COOLMORE AUSTRALIA

Drayton South EA submission

This submission is made on behalf of Coolmore Australia (**Coolmore**) in relation to major project application 11_0062 lodged by Anglo American Metallurgical Coal Pty Ltd (**Anglo**) in respect of the Drayton South Coal Project (**Project Application**). The Project Application is described in the *Drayton South Coal Project: Environmental Assessment* prepared by Hansen Bailey and dated November 2012 (**EA**).

Figure 3 - This plan depicting Anglo's preferred bund location and shape (Option 3) and Coolmore's preferred bund location and shape (Option 4).

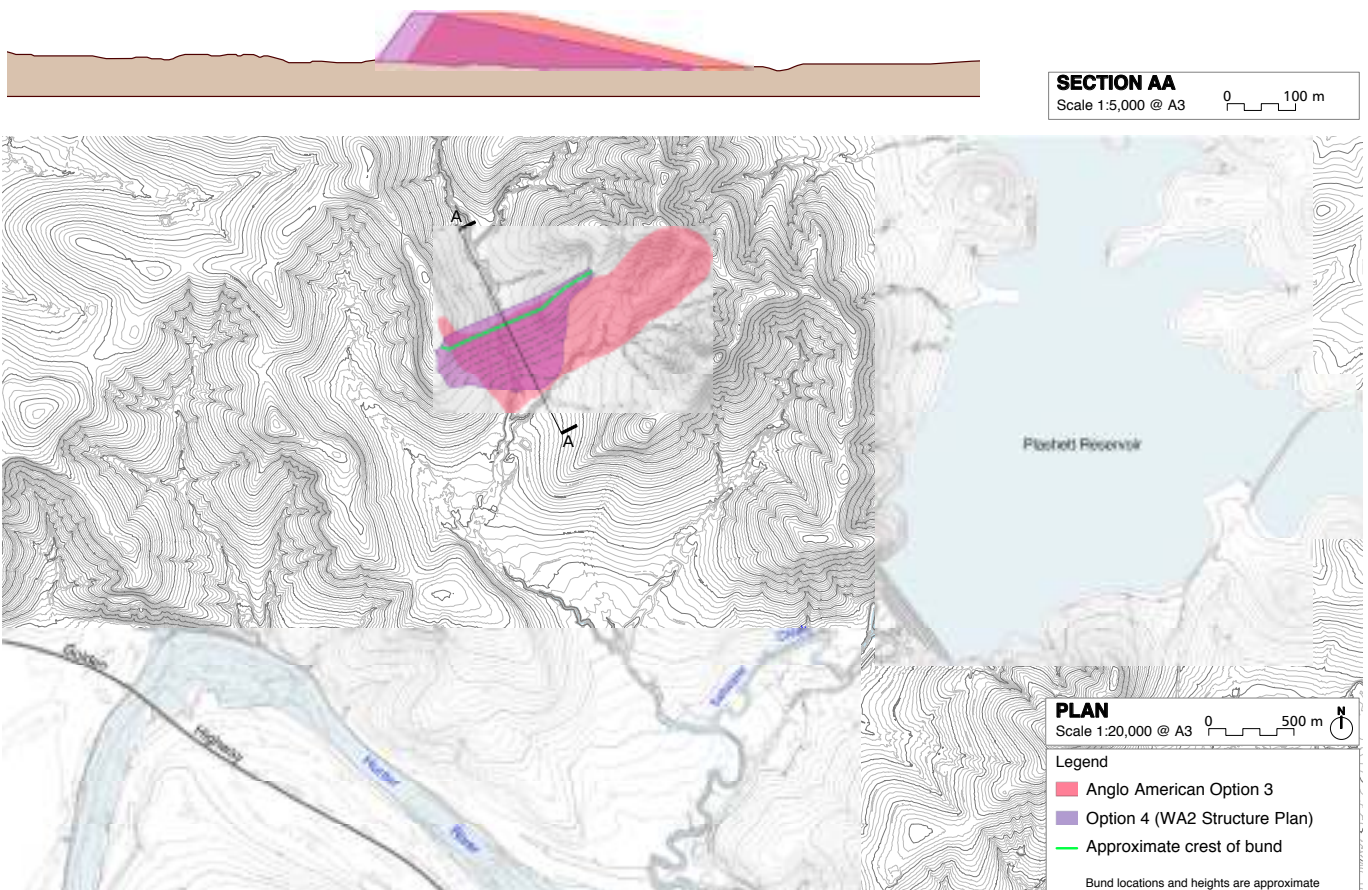
An alternative location and design of the bund, Option 4, has been proposed by Coolmore in a narrower section of the gully where a smaller bund could be constructed, as illustrated in Figure 3. This bund is designed to benefit from the natural screening effects of the two spurs which run down either side of the gully and would therefore limit the areas from which it would be visible. Being of a smaller size, it would also be faster to construct which would reduce the period of time during which Coolmore would be visually exposed to this construction activity.

While Coolmore would still be visually impacted by this alternative bund, Option 4, it would be approximately half the length and covering approximately half the area of Option 3. Coolmore would clearly prefer there to be no mining over the ridgeline into the Houston Pit however the smaller bund presented in option 4 is preferred to Anglo's Option 3.

Both bunds need to be of a similar height in order to effectively screen the open cut mine workings behind. Therefore both bunds will be exposed above the skyline from many viewpoints including the Strowan and Ellerslie residential building clusters, the internal roads and the Golden Highway.

Figure 4 - Long section of the proposed Houston Pit Bund (in pink) with a scaled overlay of the Sydney Harbour Bridge to illustrate the comparative length and height of the bund.

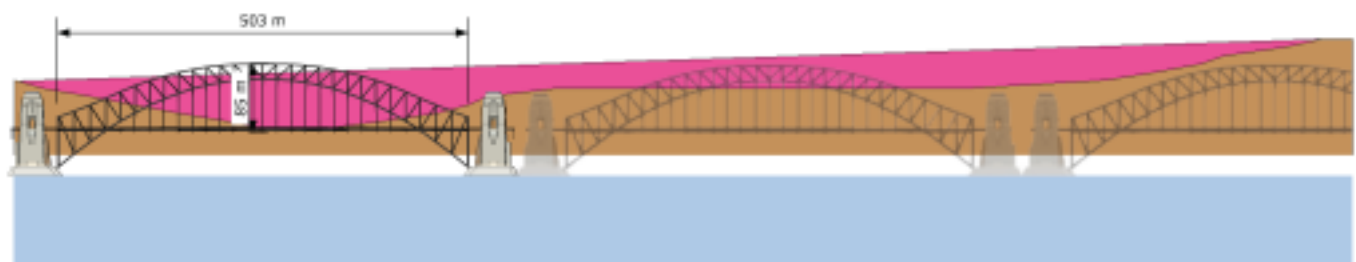
The scale of Anglo's proposed bund is difficult to comprehend in visual terms, consequently a comparative long section, illustrated in Figure 4, has been produced overlaying it with the Sydney Harbour Bridge, a landmark well known to most people to provide a sense of scale. The comparative long section clearly demonstrates that Anglo's preferred bund will be a massive piece of construction that will be difficult to blend into the existing landscape setting without creating high visual impact.

Figure 5 - Plan illustrating the range of distances between existing mining operations and infrastructure and two entry points to Coolmore, as well as the distances to the proposed Drayton South Coal Mine from these two entry points.

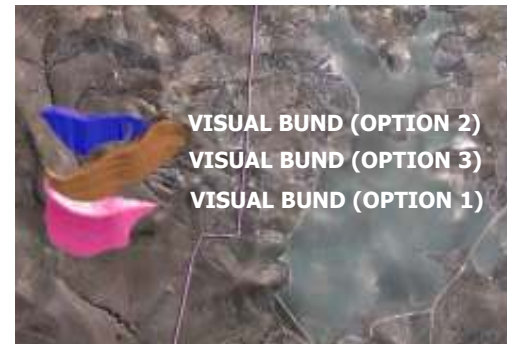
10. On page 104 of the Visual Impact Assessment report it notes that Coolmore currently has views of existing mining operations such as Mt Arthur, Hunter Valley Operations Mine and the Bayswater Power Station, however it fails to mention that these operations are between at least 5 to 10 kilometres away whereas the Drayton South mine will be as little as 1.5 kilometres from the front entrance gate to the property. This relative distances to surrounding mines and power stations from the main entry points on Coolmore are illustrated in Figure 5.
